# UNITED STATES PATENT AND TRADEMARK OFFICE

10/689,348

<b>Office Action Summary</b>	<b>Application No.</b> 10/689,348	<b>Applicant(s)</b> GRUNOW ET AL.	
	<b>Examiner</b> AMAR MOVVA	<b>Art Unit</b> 2891

## DETAILED ACTION

FIG. 2a

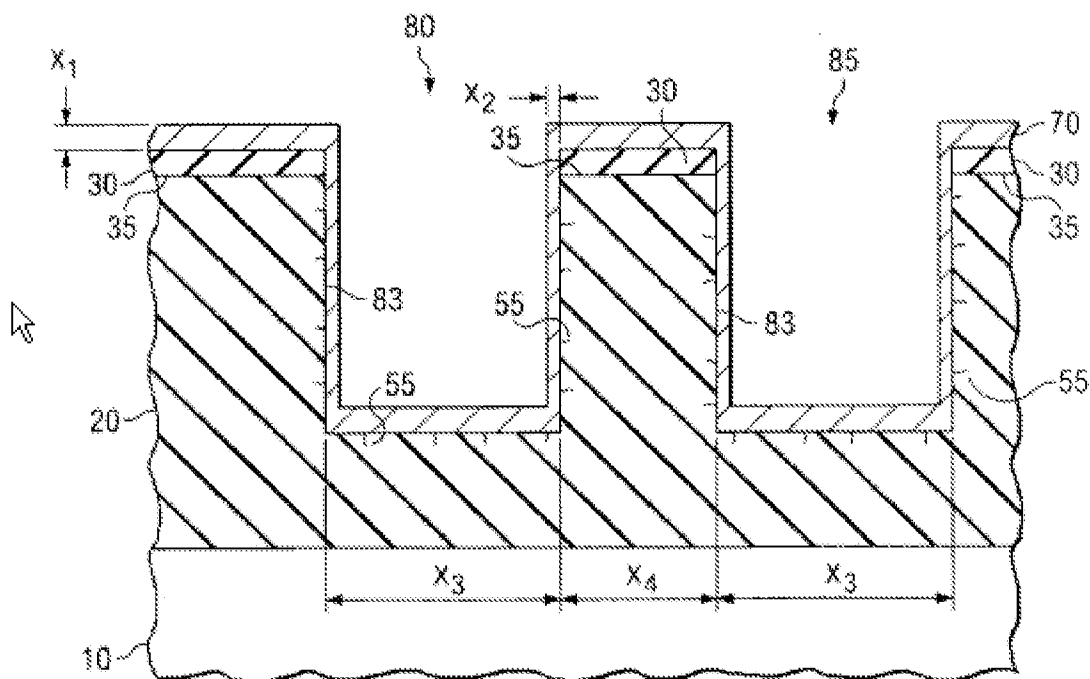
Examiner notes that applicant's independent claims state that the first contiguous barrier layer (70) is formed to thickness X1 over said upper surface (35) of the low K dielectric layer (20) within the trench and X2 on the sidewalls of the trench, wherein the ratio of X1 to X2 is 3:2. The applicable standard for determination of an instance of new matter is that the new claim matter is neither expressly nor inherently disclosed.

Regarding the lack of express disclosure, Applicant's specification discloses a 3:2 ratio vis a vis X1:X2, wherein X1 refers to the barrier layer (70) on the upper surfaces (35) of the low K dielectric outside of the trench (see e.g. fig. 2a reproduced below) and X2 is thickness on the sidewalls of the trench, thus applicant's disclosure only supplies support that the barrier layer is formed to a thickness X1 (ratio 3:2) outside of the trench. While it is possible to, in view of fig. 2a, to find support in applicant's disclosure that a portion of the contiguous barrier layer (70) is thicker in the trench than

on the sidewalls of the trench it is not sufficient to support a claim that the ratio of X1 to X2 is 3:2 with X1 in the trench.

Furthermore the disclosure does not inherently show a 3:2 ratio since issues that would cause the thicker portion of 70 in the trench vis a vis thicker portion outside of the trench to vary (in PVD and CVD as specified in the specification as the methodology of depositing layer 70) would be poor step coverage depending on the specific materials of the deposition, a lack of knowledge as to what angles were used in the deposition, and whether or not the deposition may have had multiple steps with masks to isolate certain areas for deposition.

a. Applicant argues that the subject matter in applicant's specification traverses examiner's new matter rejection. Specifically applicant states: "Page 8, lines 4-5 and page 12, lines 4-5 of the original specification literally state that the contiguous liner layer (or barrier layer) is formed in the trenches. Page 8, lines 13-15 further states "In an embodiment X1 represents the thickness of the non- conformal layer 70 formed over the upper surface 35 of the low K dielectric layer 20"." This argument misconstrues examiner's position. Examiner's does not allege that the barrier layer 70 is not in the trench. Rather examiner merely notes that thickness of layer 70 changes in different locations. Layer 70 is X1 above the surface 35, X2 over the sidewalls of the trench, and an unknown thickness at the bottom of the trench. Furthermore applicant's quotation from the original specification stating the X1 barrier layer 70 thickness is above the surface 35 reinforces examiner's position. The surface 35 in fig. 2a is referenced 3 times to the surface outside the trench. Surface 35 is never shown to be in the trench. Therefore the specification expressly only supports a thickness X1 above surface 35, which is outside the trench.

b. Applicant argues that it would have been redundant to re-label the bottom portion of the trench barrier layer since it is the same as the layer 70 over the barrier 30. Applicant's argument illustrates the lack of an express disclosure of

the thickness of the bottom portion of the trench barrier layer. One of ordinary skill in the art would indeed assume that a thickness illustrated in one section of layer is consistent throughout **had the layer been uniform**. However, barrier layer 70 varies in thickness. One of ordinary skill in the art would not read different portions of layer to be both of X1 thickness when an intervening portion of the layer is of a different thickness and thus express labeling of the bottom portion of the trench barrier layer is necessary.
